STAFF REPORT

DATE: 8/26/19 REGULAR

Variance Requests - 9447 Stillwater Blvd. **AGENDA ITEM:**

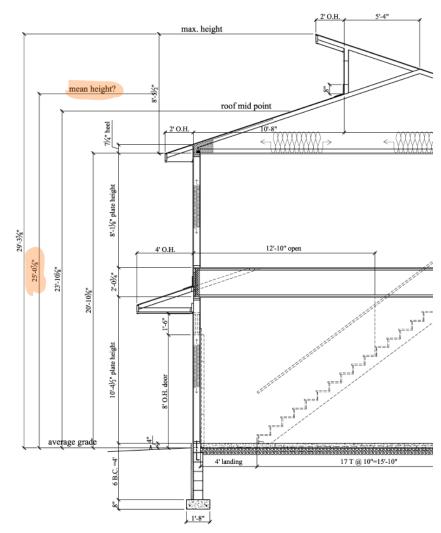
When reviewing accessory building requests Staff has uses the "Building Height" definition as the standard for determining the height of structures. The diagram to the right lists out the different measure points that are listed out in the definition. If the height variance is denied for the applicant, there would be the option to seek out Washington County and consult with them on having the property reclassified as outlined in section 154.213. If that were to happen Staff does not necessarily see why the applicant would be restricted to the 22 ft. height requirement.

At this point Staff does not believe the request to have a structure taller than what is allowed meets the criteria for variance approval. However, the last sentence in section 154.406 does allow structures to exceed the 22 ft. height requirement with specifically listed items. If the Commission believes that the upper roof/window qualifies as a decorative attachment this could put the applicant in a more favorable position. If this is determined to be

the case then the highest point would be measured at a lower position which would bring all the other measurements down. Then the projection would have to be reduced down to 25 ft. Staff does believe there would be grounds to make this determination as the applicant has added this window to match the design of the home, constituting a "similar decoration."

- 1. That the Applicant obtain all applicable permits including but not limited to a City building permit including a grading, erosion control, and storm water management plan approved by the City Engineer.
- 2. That the Applicant must reduce the height of the building to 22 ft. unless the property is reclassified to Agricultural. If reclassified, the applicant can increase the structures height to 25 ft.
- 3. If approved this variance approval is valid for 1 year and would expire on XXX. (date set after council approval)
- 4. One of the other smaller accessory buildings noted on the survey must be removed prior to the issuance of a building permit of the new accessory structure.
